**UNITED STATES OF AMERICA
NUCLEAR REGULATORY COMMISSION**

SOUTHERN CALIFORNIA EDISON COMPANY

(San Onofre Nuclear Generating Station, Units
2 and 3)

1ST AFFIDAVIT OF JOHN H LARGE

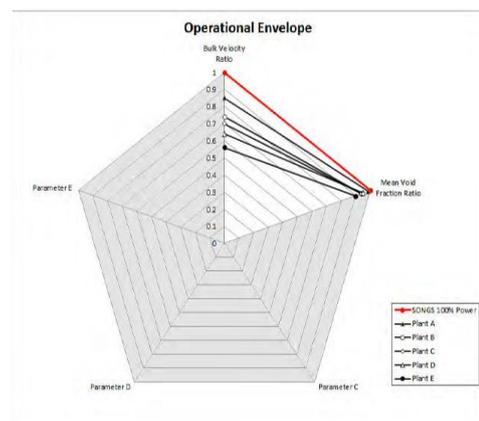
8.2 Figure 4-3 (shown right) of the *Tube-to-Tube Report* does not plot, as it purports, [p17, ¶3]¹⁷ ‘many factors’ providing a periphery that ‘defines the operational parameters’ for a particular plant.

8.3 As I see it, the diagram is endeavoring to portray the energy balance that determines the onset of fluid elastic instability (FEI). Essentially, FEI results when (via fluid dynamic forces acting the tube) the energy input exceeds the amount of energy that can be dissipated by that rate system damping available.

8.6 The diagram represents only two groups and not ‘many’ factors referred to by AREVA. The two groups represented are described as the *Bulk Velocity Ratio* and *Mean Void Ratio* that, logically, represent the factors making up input and output energy transfers respectively. Of these, the *Mean Void* is straightforward being a linear outcome, whereas the *Bulk Velocity* is the energy outcome of a force deriving from the square of the impinging velocity ($\rho v^2/2$).

8.7 It is not clear if the vertical axis of the Figure 4-3 represents the velocity (v) or, more correctly, the square of the velocity ($\rho v^2/2$), that is being more representative of the comparison between the SONGS and other SGs.

8.8 The next difficulty I have with Figure 4-3 is what exactly is meant by the *Bulk Velocity* and *Mean Void* parameters?

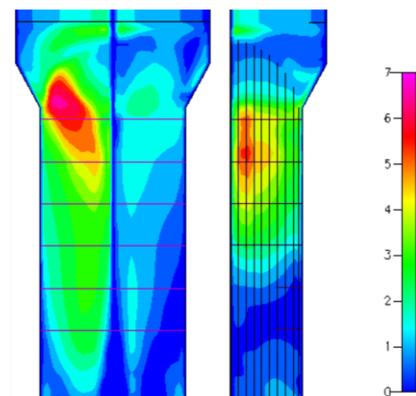
8.9 For example, consider the *Bulk Velocity*: SCE shows [p43, Figure 8-3]¹¹ the velocity contours (v) predicted active in the SONGS U2 RSG at 100% power. The plot (right) shows the greatest velocity ■ present in the top section of the hot-leg in the U-bend region with the dispersal of this velocity represented *out-of-plane* (LH diagram, left side) and *in-plane* (RH diagram) - these are regions are where FEI is predicted to have been most active in the tube bundle.

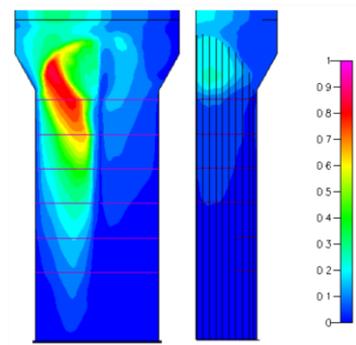
8.15 Much the same may be concluded for the *Mean Void* comparison of Figure 4-3. The SCE plot (right) of *steam quality* [p39, Figure 8-1]¹⁷ indicates the complexity of the two-phase fluid in the SONGS RSG tube bundle, again presenting the same uncertainties, if not impossibility, in drawing meaningful comparisons with the comparative plants.

9.1 “. . . Figure 5-1 in the Tube-to-Tube Report compares the same parameters as in Figure 4-3, but for operation at 70% power. It appears from Figure 5-1 that the bulk fluid velocity for SONGS is at the high end of the experiential range.

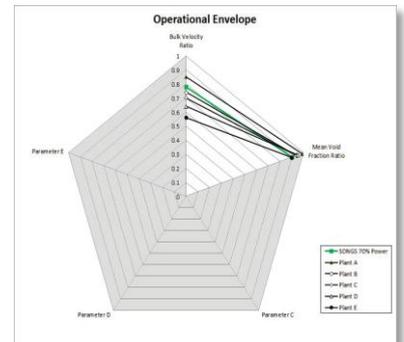
9.2 I have previously aired my reservations and doubts about the spider diagram representation of Figure 4-3 {¶8.2 to 8.17} - much the same applies to Figure 5-1.

9.3 AREVA claims [p43, ¶4]¹⁷ that Figure 5-1 demonstrates:
